ARCHITECTURAL IMPACT ASSESMENT/DESIGN RATIONALE

**32 ST PATRICKS COTTAGES,
RATHFARNHAM, DUBLIN 14**

ADDITIONAL INFORMATION RESPONSE TO PLANNING REF SD21B/0641

August 2022

Windows prior to change

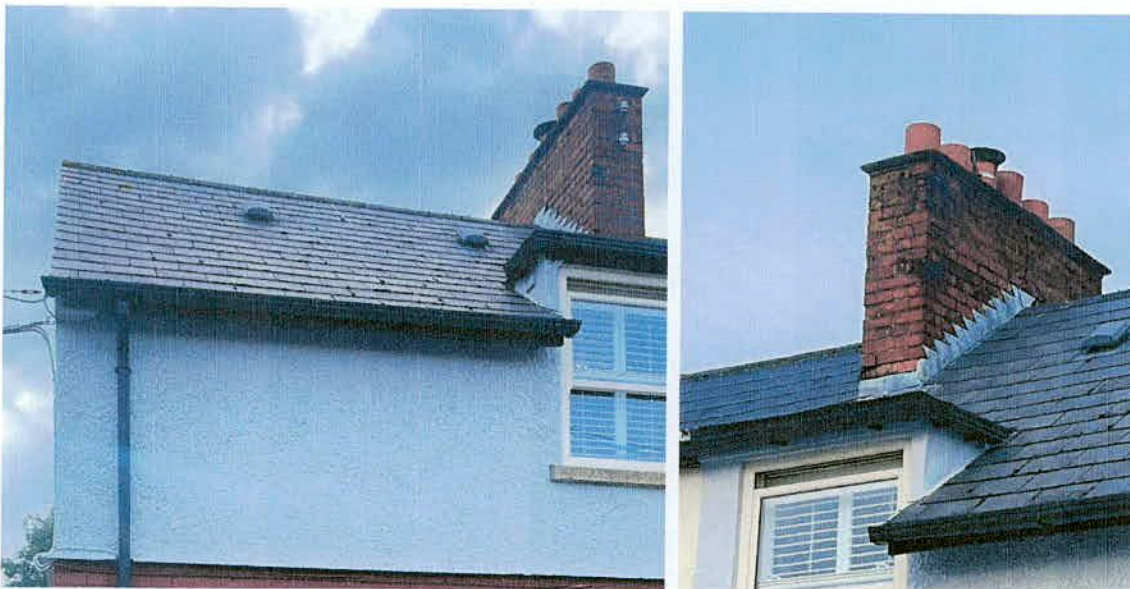
The original windows from the property were removed quite some time ago and there have probably been a couple of replacement windows prior that would not fit the character of the original build. The applicant was forced to replace the windows that were in situ as they did not provide escape from the bedrooms in the event of a fire. These windows have already been removed, and Heritage grade windows have been installed to the existing opes.
